TO: Casey Adragna, Adragna Architecture
FROM: Amber Wood Hicken, Planner I
DATE: 5/5/25
SUBJECT: Douglas 234 Multitenant, Site Plan
Review Comments 01

SITE PLAN
HORSE CREEK COMMERCIAL
 LOT 10B, DOUGLAS 234 FILING NO. 6, AMENDMENT 2
 A PORTION OF THE SW 1/4, SE 1/4, SECTION 29, T6S, R66W, 6TH P.M.
 TOWN OF PARKER, COUNTY OF DOUGLAS, STATE OF COLORADO

SITE DETAILS
 DOUGAS 234 FILING NO. 6, AMD. 2
 DATE: FEBRUARY 17, 2025

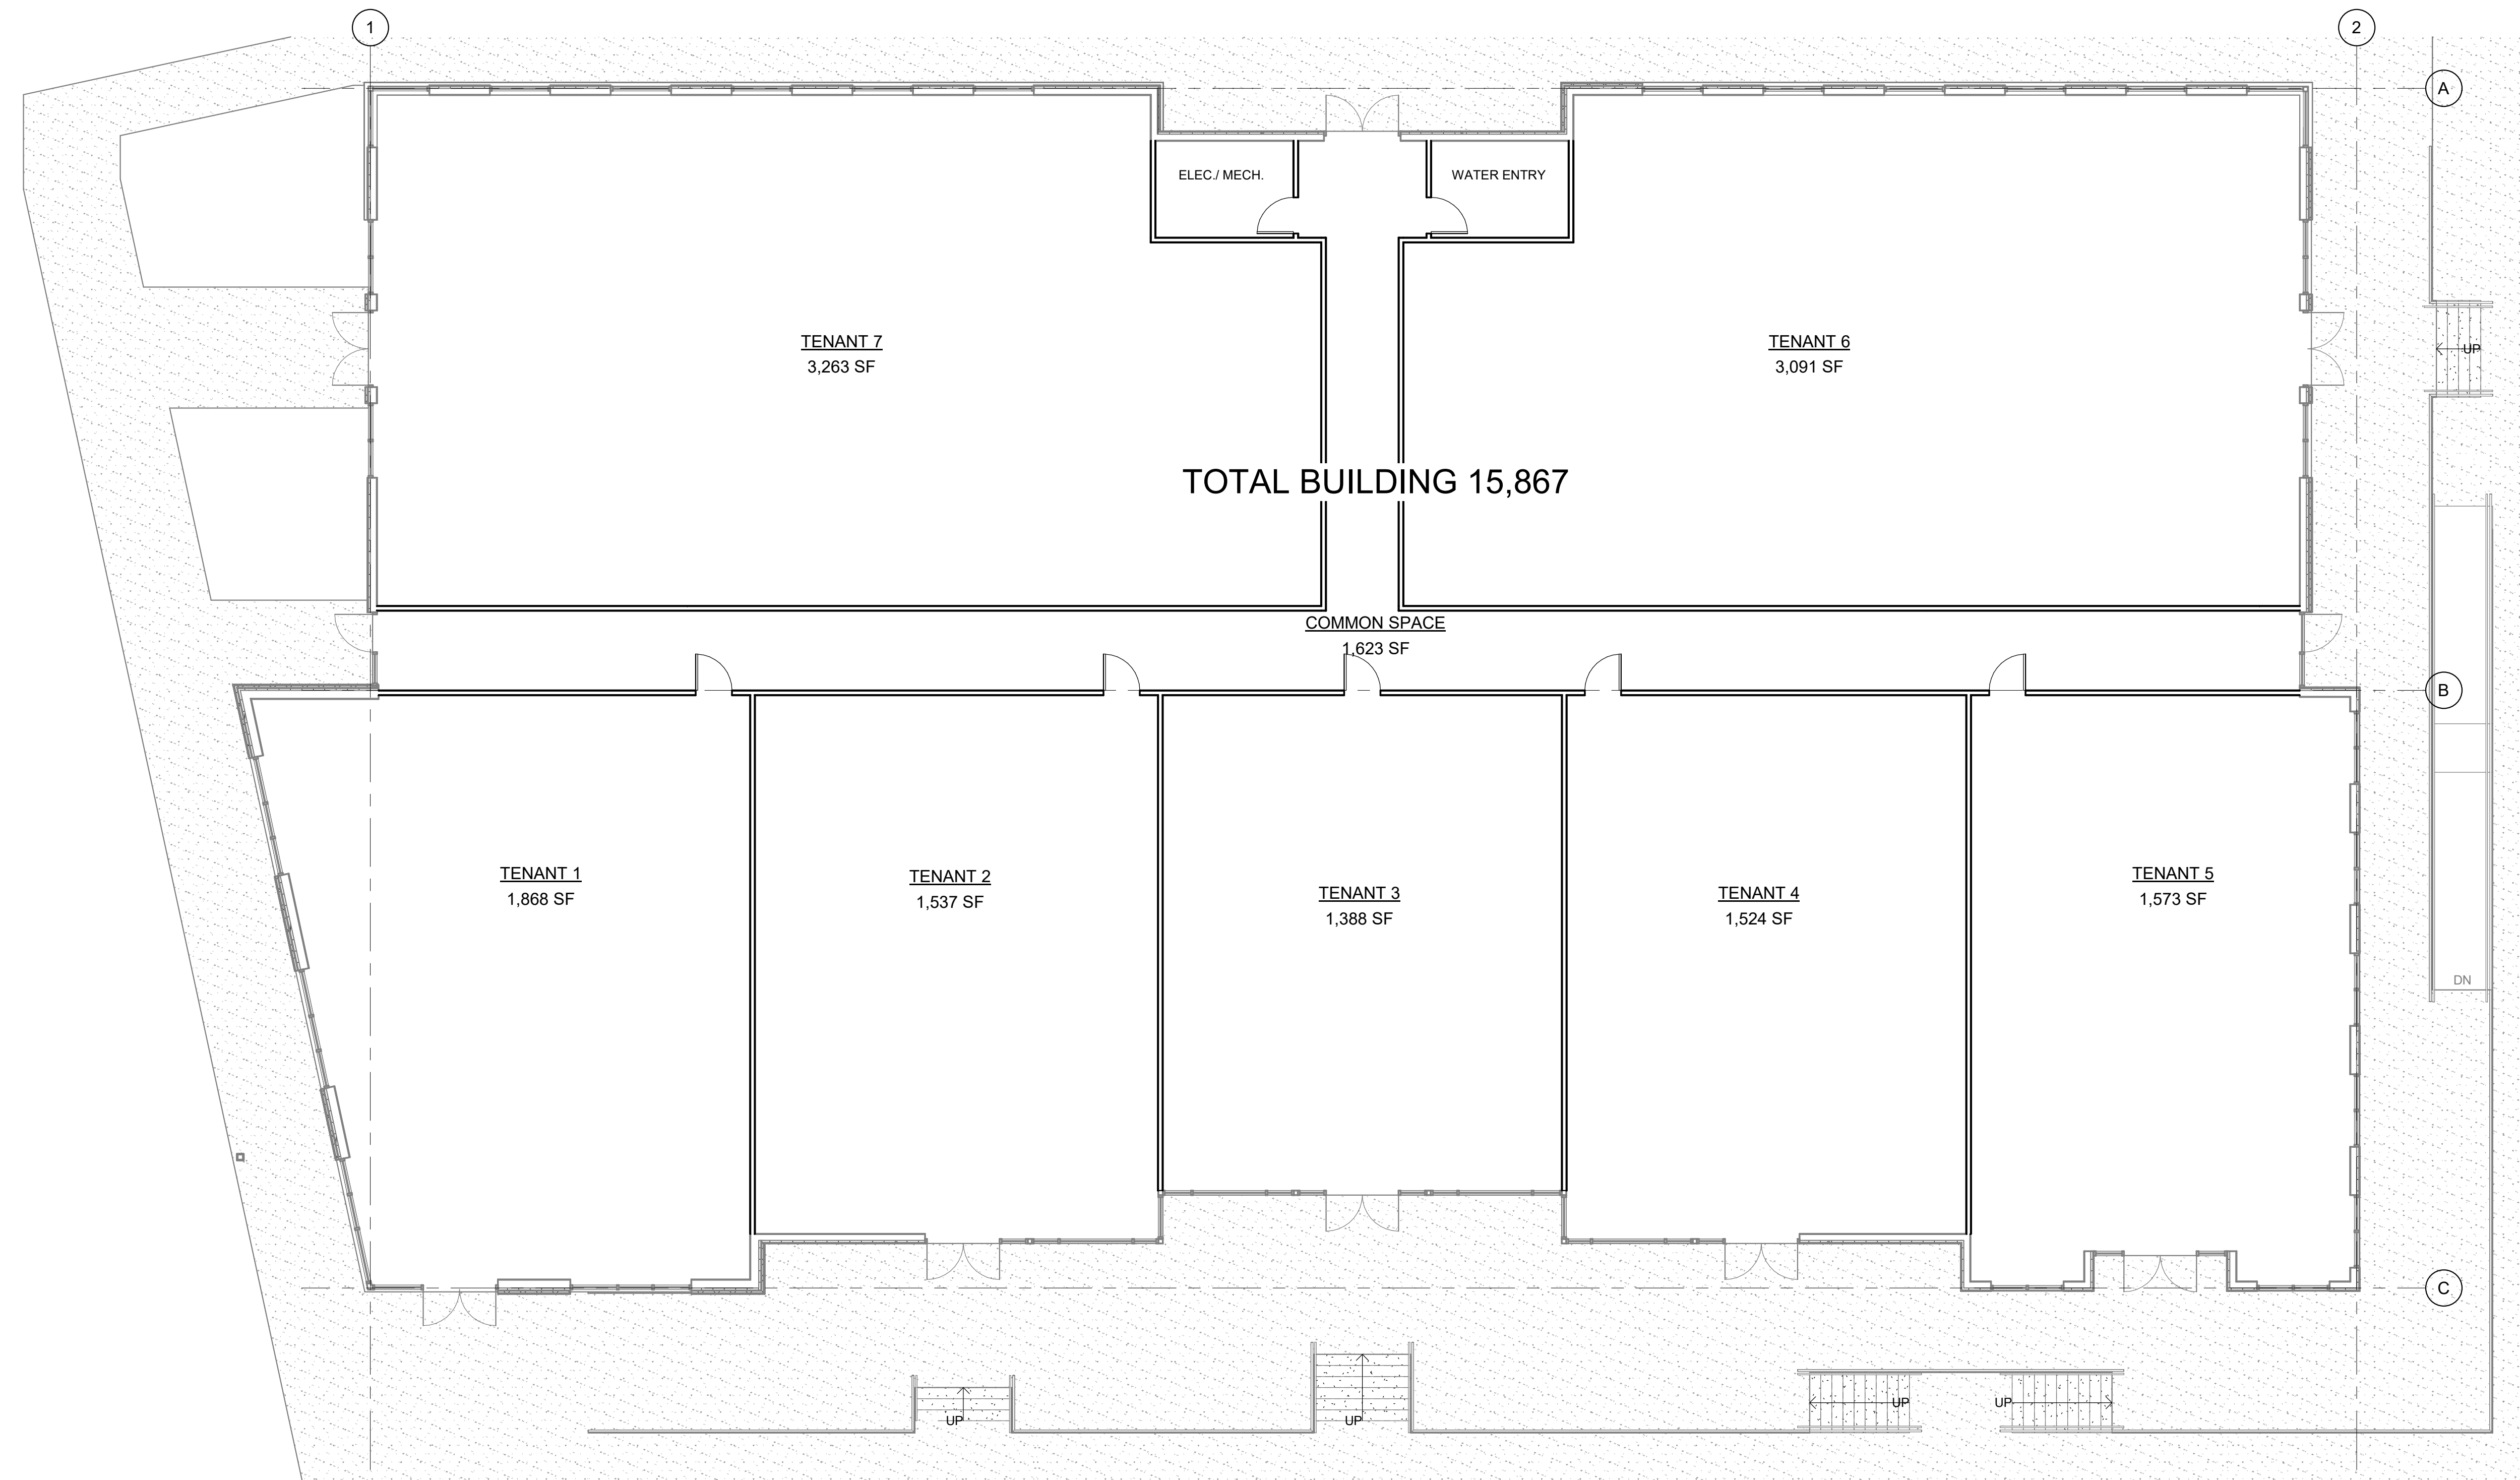
spec needed for free standing retaining wall. image, height, color, material.

spec needed for railing - color, material
